THE CITY OF SAN DIEGO
Development Services Department
7650 Mission Valley Road, San Diego, CA 92108

Project Address 8332 Calle Del Cielo
San Diego, CA 92037

Project Type Discretionary Project

DSD-Engineering Review

CONSTRAINTS
MAP
C-01

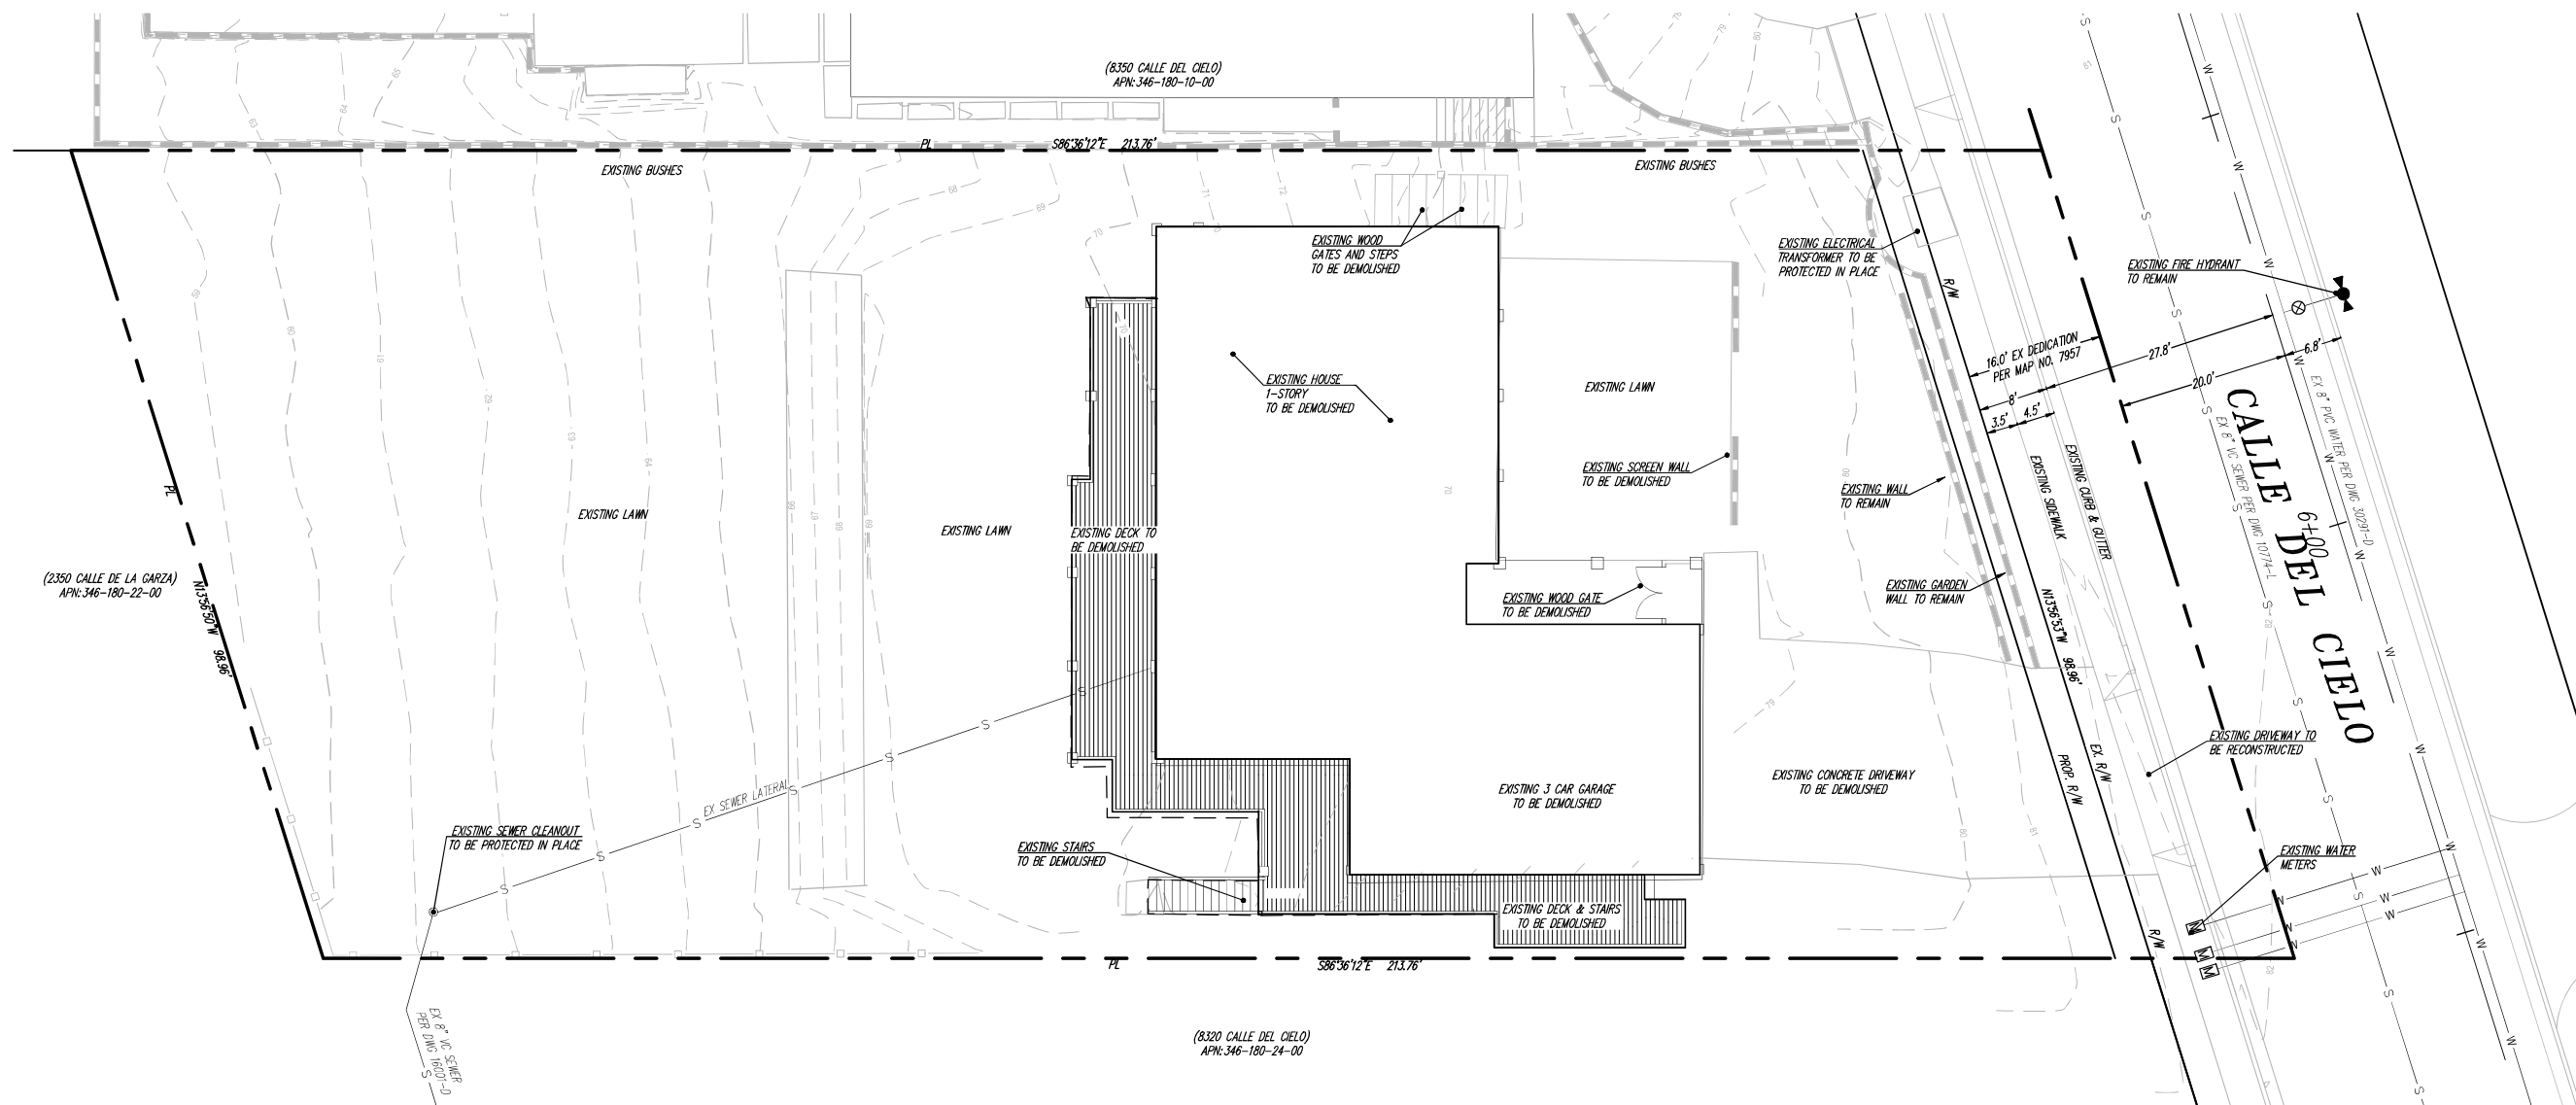
Revise the Calle de Cielo cross section on sheet C-01 to show and callout proposed ROW dedication.

- a. A102 - Add a call out for existing and proposed linework in sections A and B. Dimension existing parkway, curb to curb, and PL to PL.
- b. C-01 - Revise cross section to state "ex R/W" and "Prop R/W". Revise site plan to call out existing and proposed R/W. Add dimensions for proposed dedicated area.
- c. C-02 - Revise site plan to call out existing and proposed R/W. Add dimensions for proposed dedicated area.
- d. C-03 - Revise site plan to call out existing and proposed R/W.

Comment 24
See sheet C-1. Additional label has been added.

Comment 113
Existing and proposed ROW labels have been added.

CONCEPTUAL GRADING & UTILITY PLAN

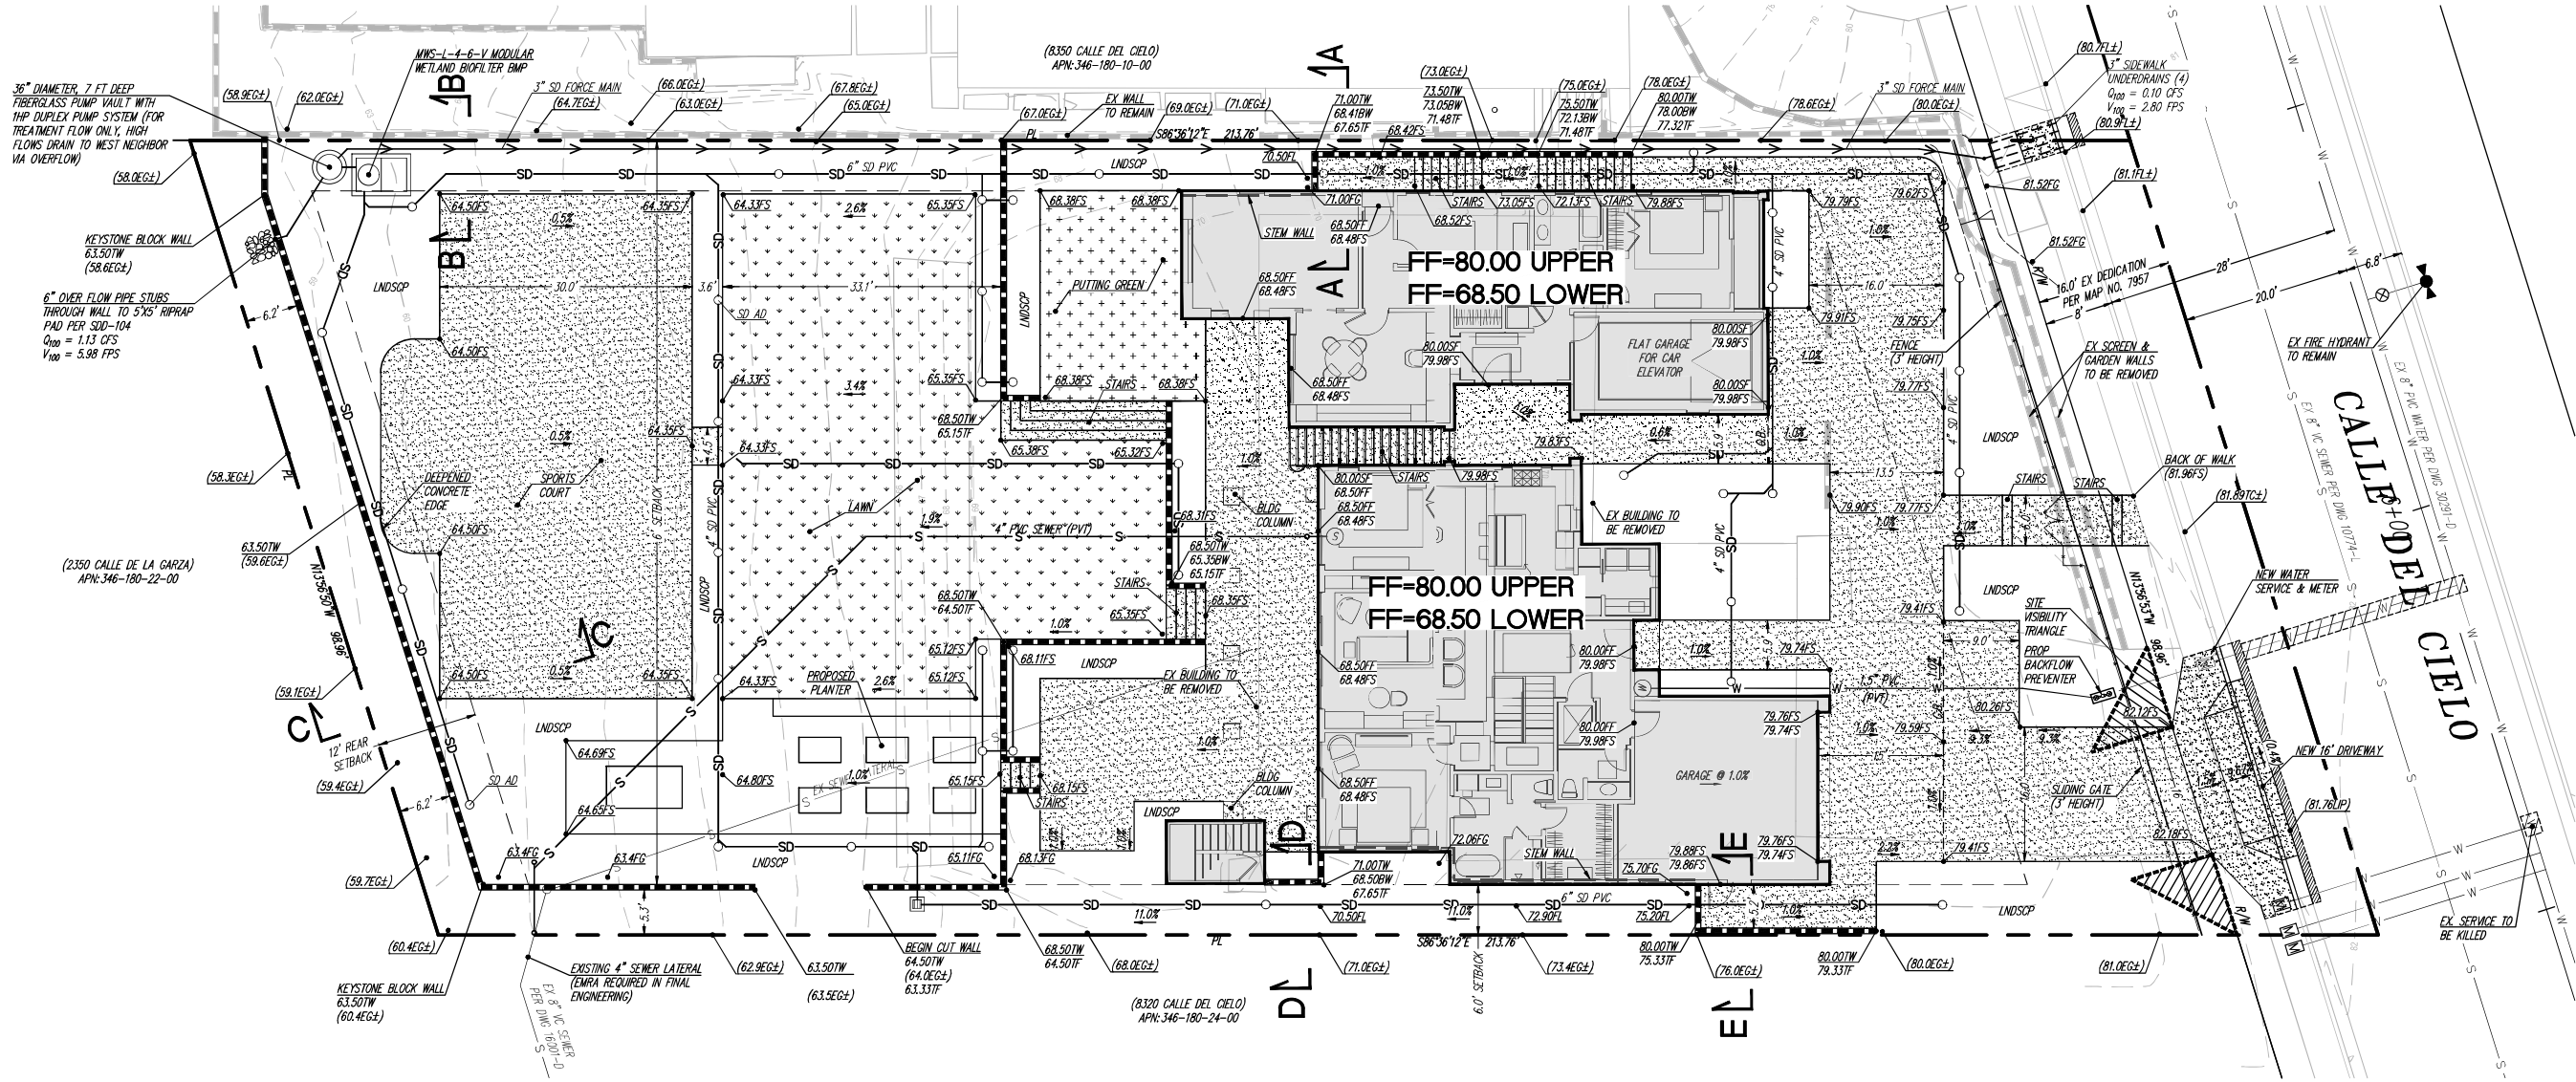
Drainage report and calculations state outlet at Calle Del Cielo is a proposed curb outlet. Please revise plans, exhibits and details to show and call out a proposed curb outlet. There is a discrepancy on the following sheets stating a sidewalk underdrain is proposed, please revise: A101, C-02, C-03.

Revise site and grading plans to show and call out proposed from yard pedestrian gate and fence as called out in landscape plans. A portion of the proposed fence appears to be within the visibility triangle, revise for next submittal.

Comment 111
The Drainage Study and the Plans have been updated to show sidewalk underdrains. The reports and the plans are now consistent.

Comment 114
See sheet C-2. 3' high fence has been added and labeled.

L-1.2

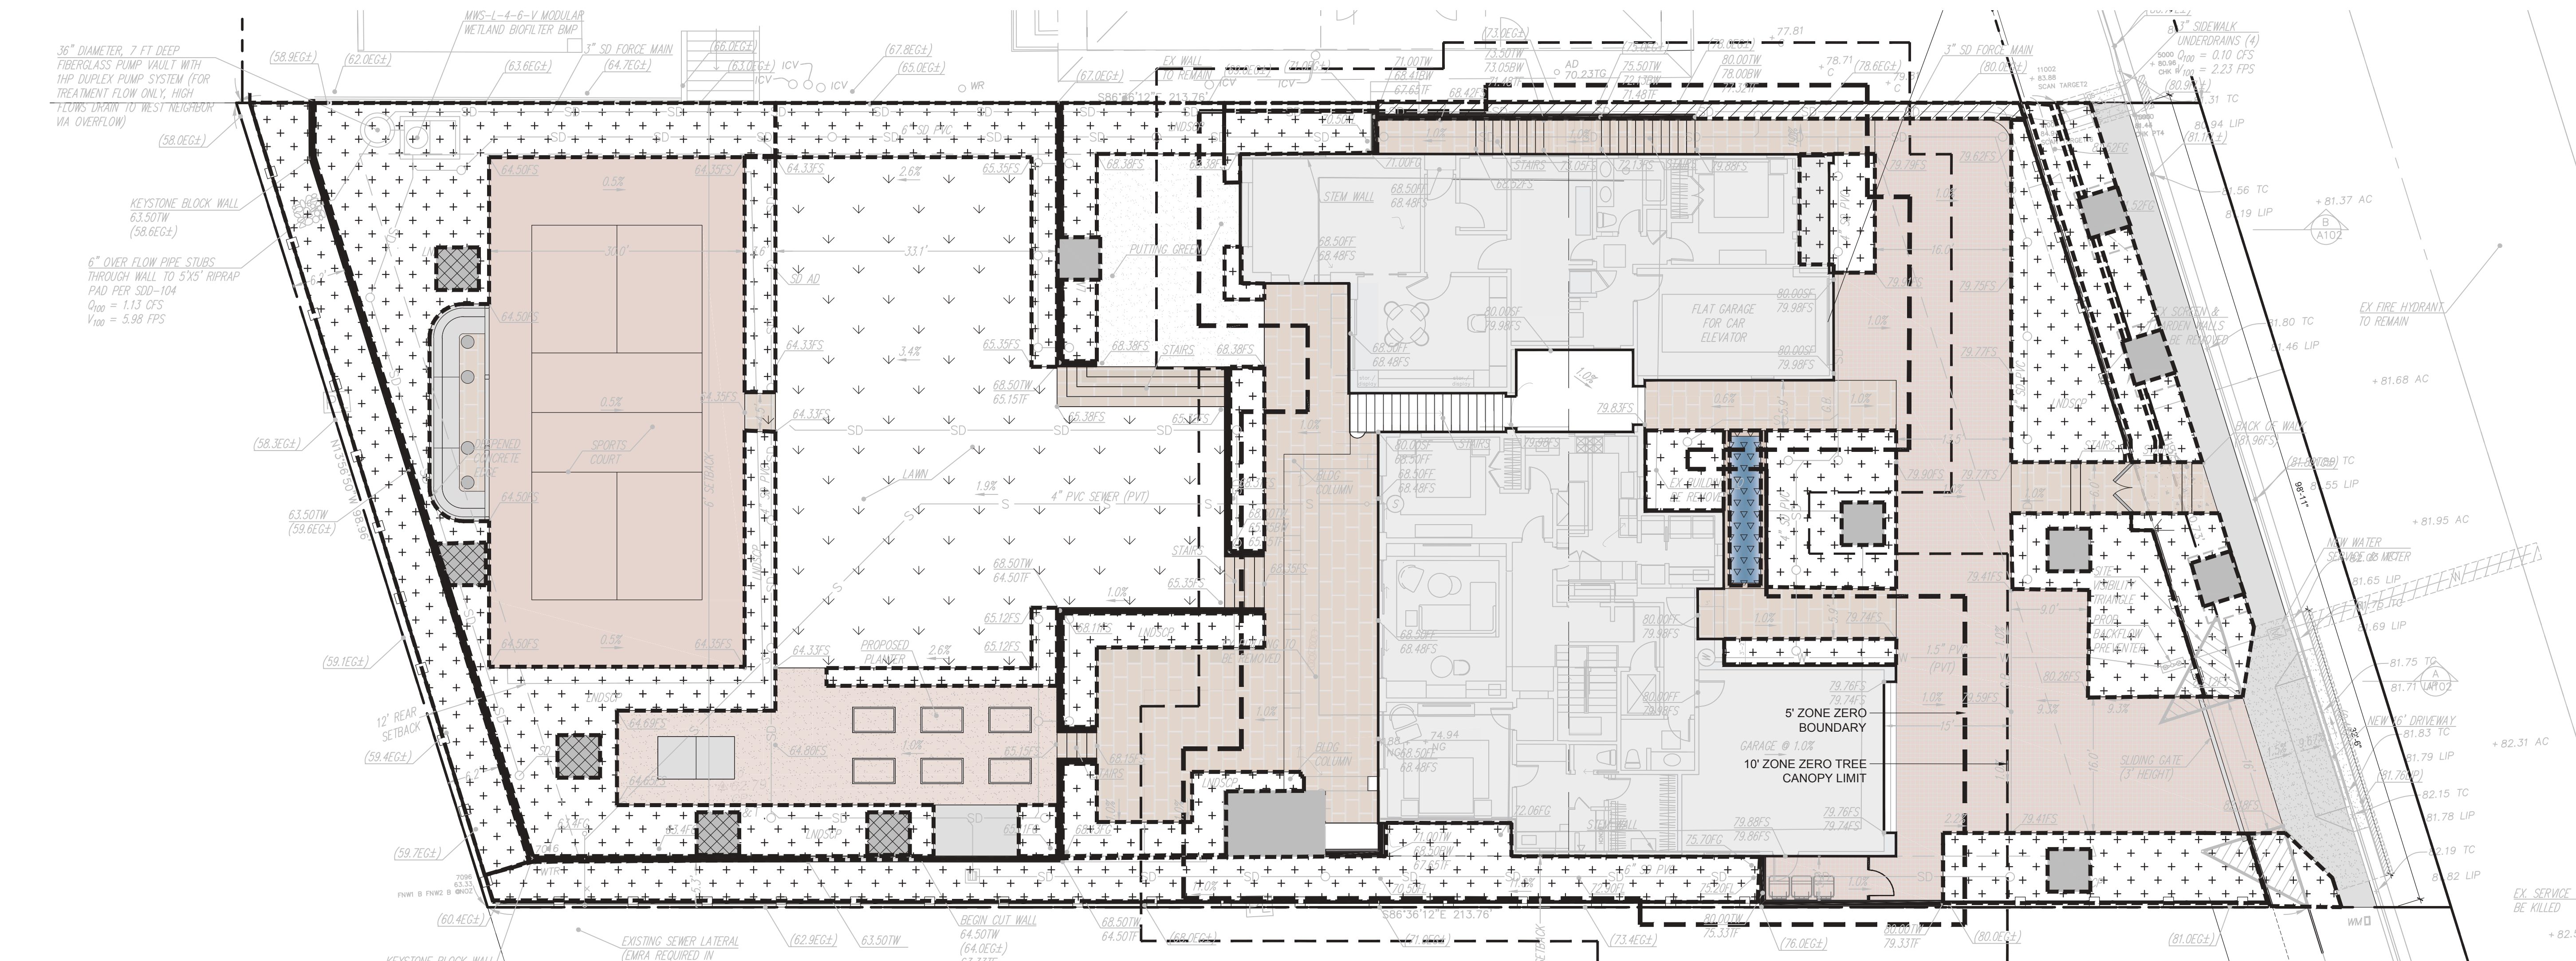
Roof Eave Boundary: Clearly label the roof eave overhang on the brush management plan. The roof eave shall be taken into account when establishing brush management zones per SDMC 142.0412(g)(2).

Table 142-04H Note: It is unclear why the Table 142-04H was provided. Zone widths are not consistent with what is shown on the plan set or SDMC Table 142-04H. Please remove as non-standard zones apply for the project at hand.

Brush Management Irrigation Note: Please provide a note indicating that a permanent, below-grade irrigation system will be used per SDMC 142.0403(c) directly on the brush management plan.

Brush Management Program Notes: Provide excerpts from the City's updated Brush Management Program notes of the Municipal Code and Landscape Standards directly within the plan set. These excerpts describe the procedures for creating and maintaining the brush management zones.

Provide the following note on the Brush Management Plan: "The Owner/Permittee shall schedule a pre-construction meeting on site with the contractor and the Development Services Department to discuss and outline the implementation of the Brush Management Program."

Provide the following note: "Brush management activities are prohibited within coastal sage scrub, maritime succulent shrub, and chaparral habitats during the breeding season of federally protected species, from March 1 to August 15, except where documented to the satisfaction of the City of San Diego that the thinning would be consistent with the conditions of species coverage described in the City of San Diego's MSCP Subarea Plan."

Provide the following note on the Brush Management Plan on the Brush Management Plan: "Upon repair or replacement of all structures in Zone 1, upgrades shall be of noncombustible, one-hour fire-rated or Type IV or heavy timber construction."

Provide the following note: "Offsite brush management shall be the responsibility of adjacent property owners. For fuel-load maintenance issues, contact the Fire-Rescue Department's Fire Hazard Advisor – Brush/Weed Complaint line at: (619) 533-4444."
